ADDENDUM NO. 4

May 19, 2022

**LIBERTY INTERMEDIATE SCHOOL ADDITIONS
AND RENOVATIONS
Chesterton, IN 46304**

This Addendum consists of Pages ADD 4-1 through ADD 4-4 and attached Addendum No. 4 from Gibraltar Design dated May 18, 2022 and consisting of 4 pages and 47 drawings.

© GIBRALTAR DESIGN SHEET
B EP102

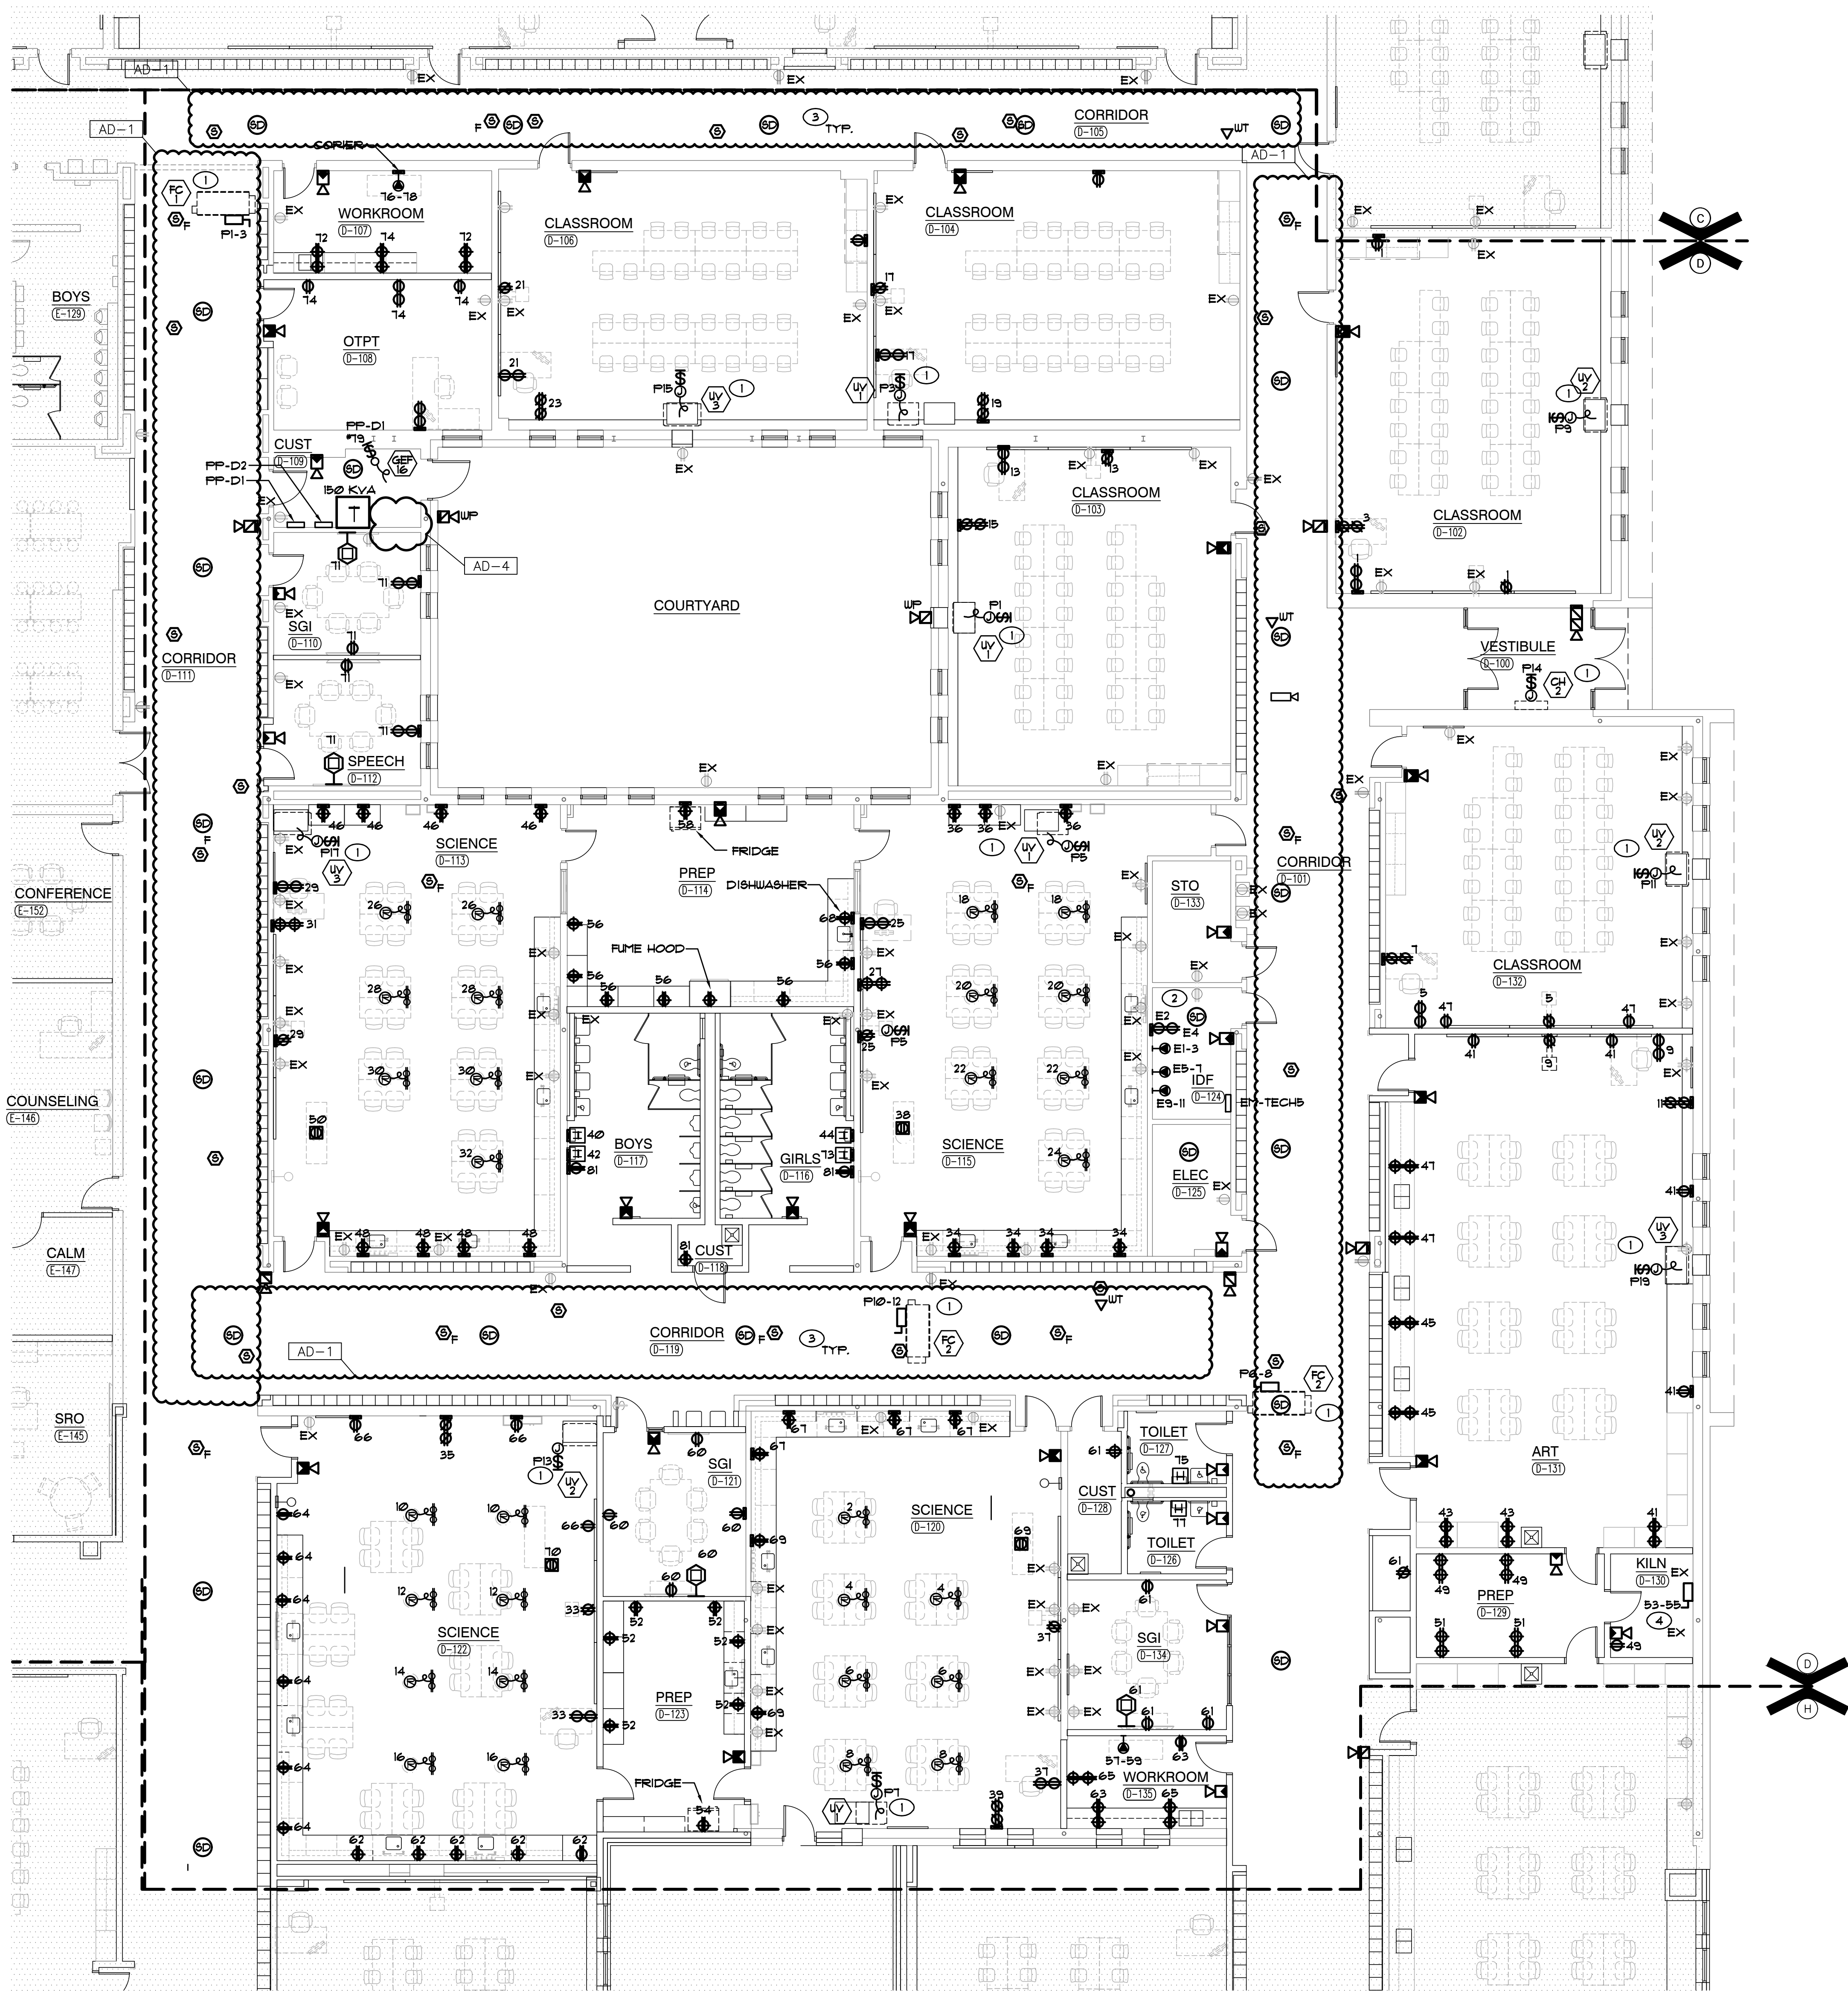
A. Refer to Two (2) revised full-size drawings, included in this Addendum, for the following revisions:

1. Revised bathroom hand dryers to existing.
2. Revised sheet notes to accommodate hand dryer changes.

E-502

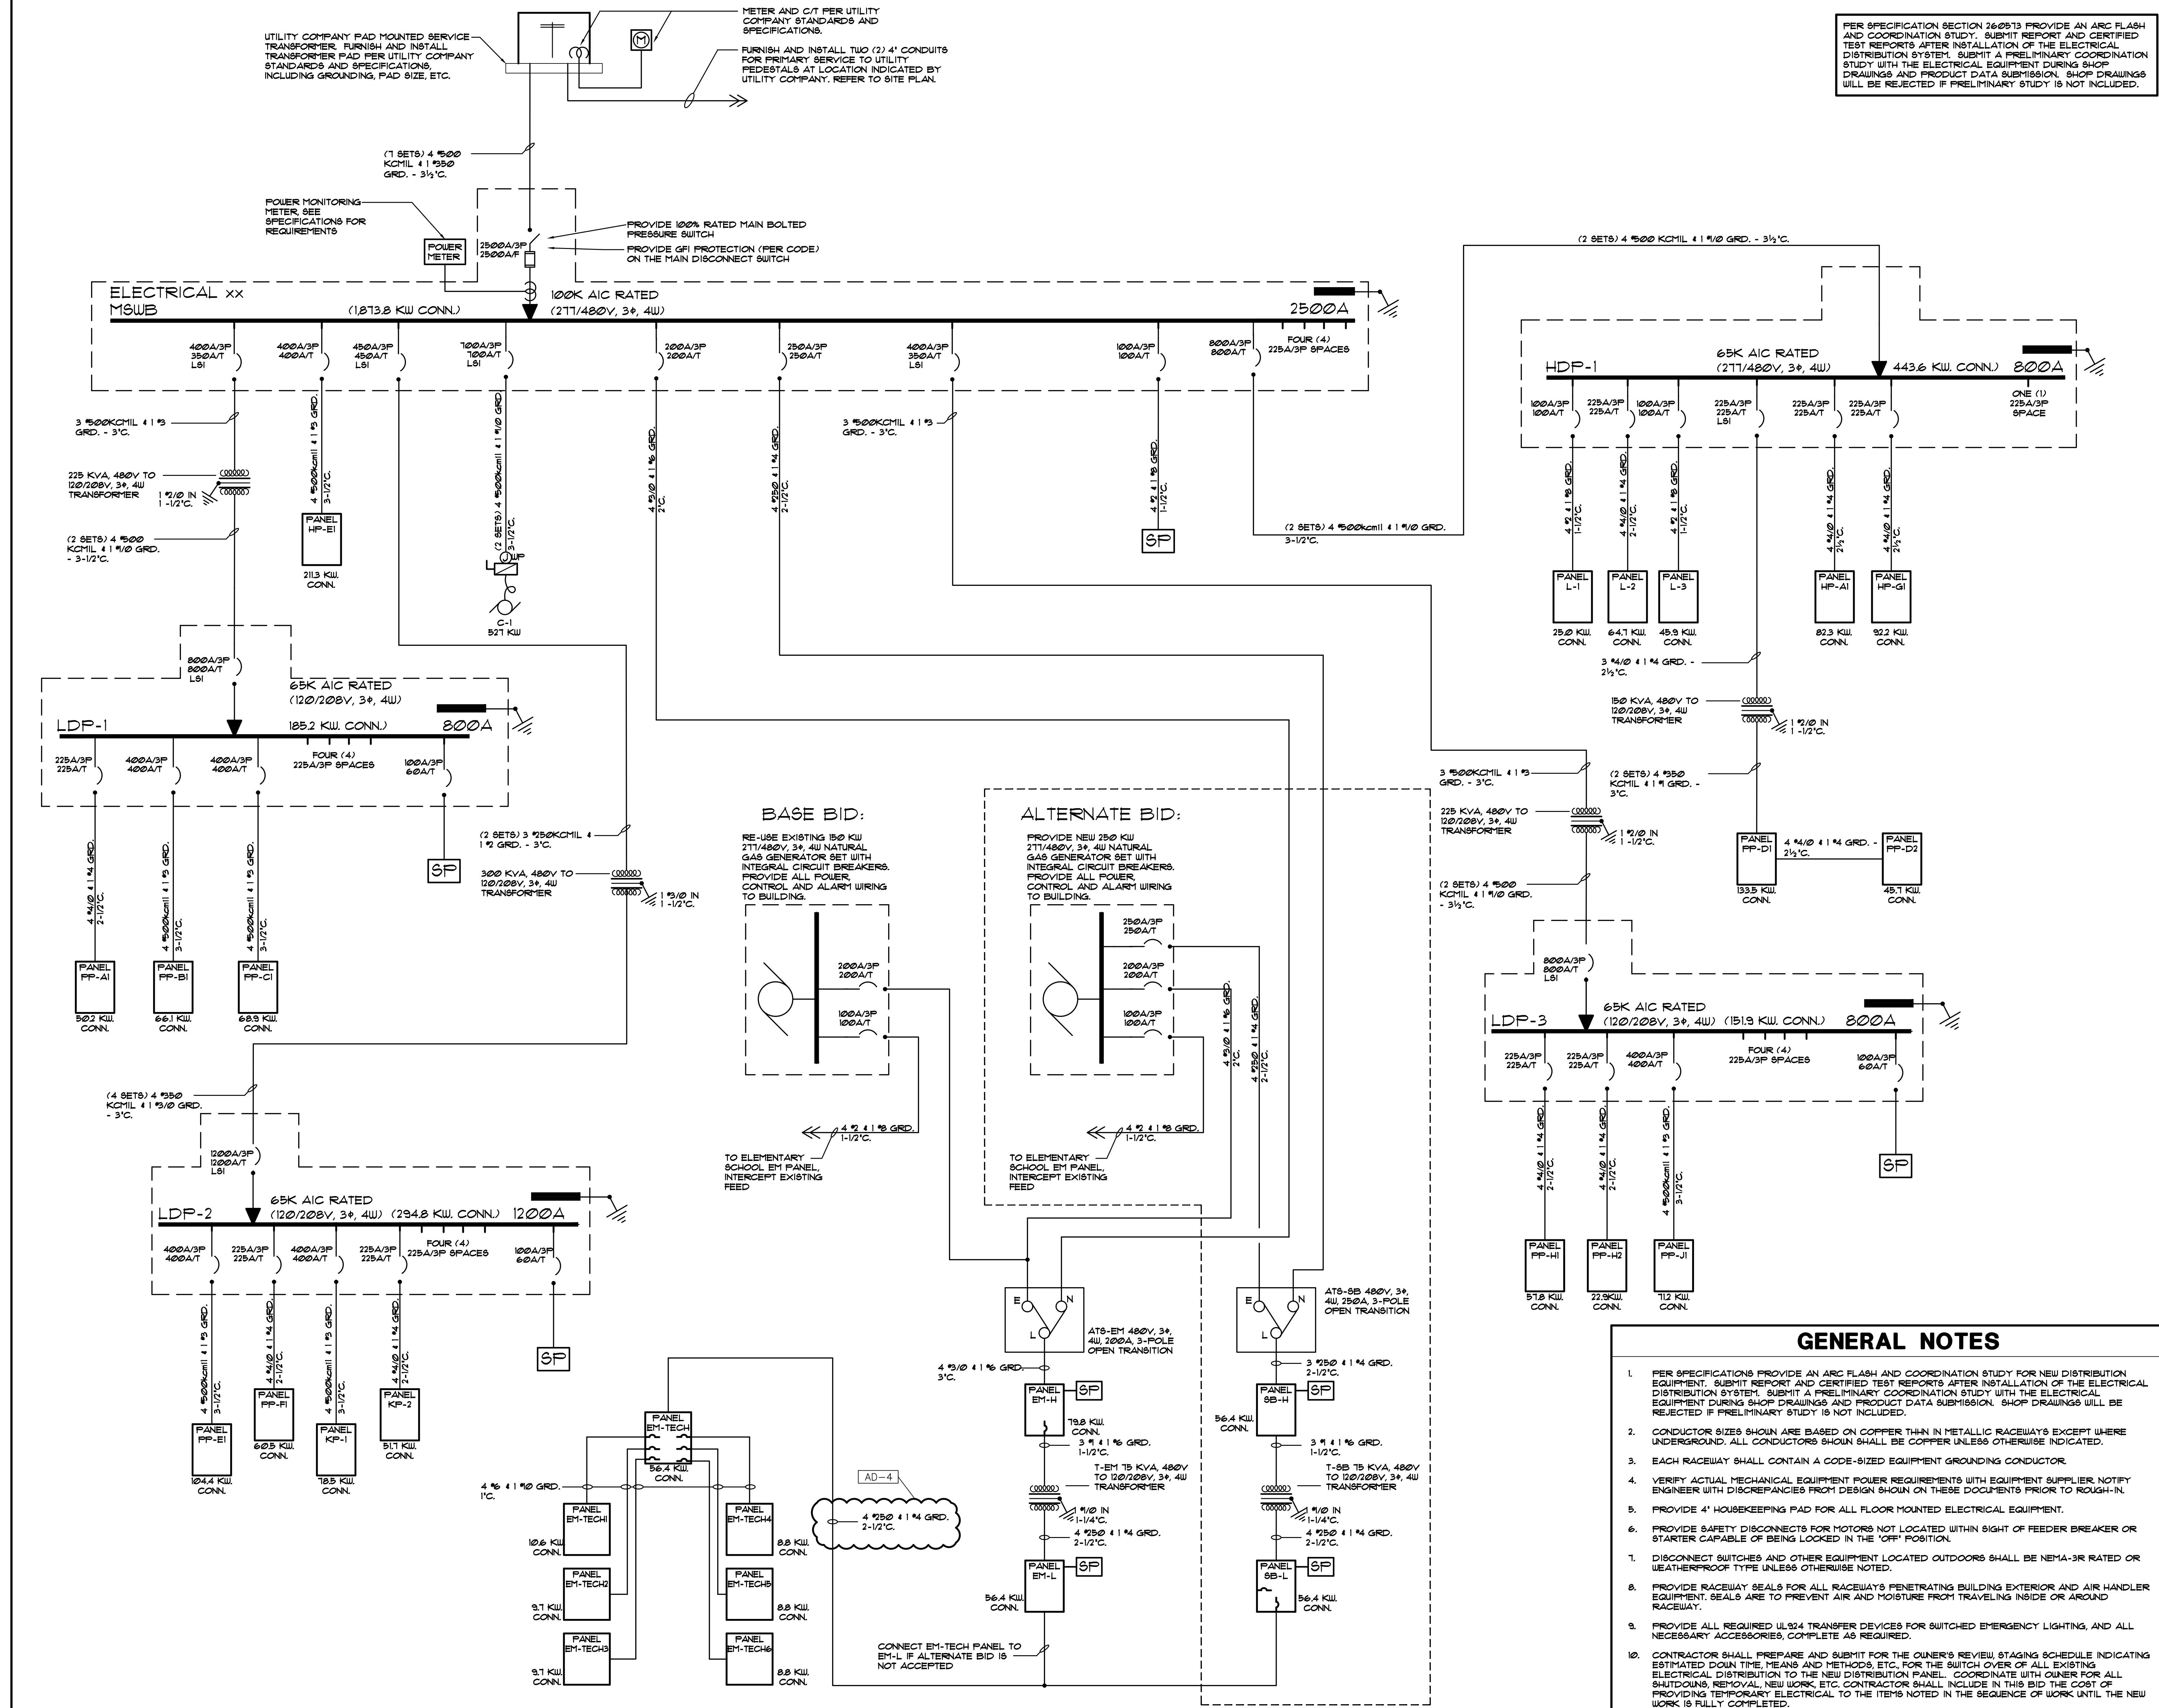
- A. Refer to revised full-size drawing included in this Addendum, for revised feeder size to EM-Tech Panel.
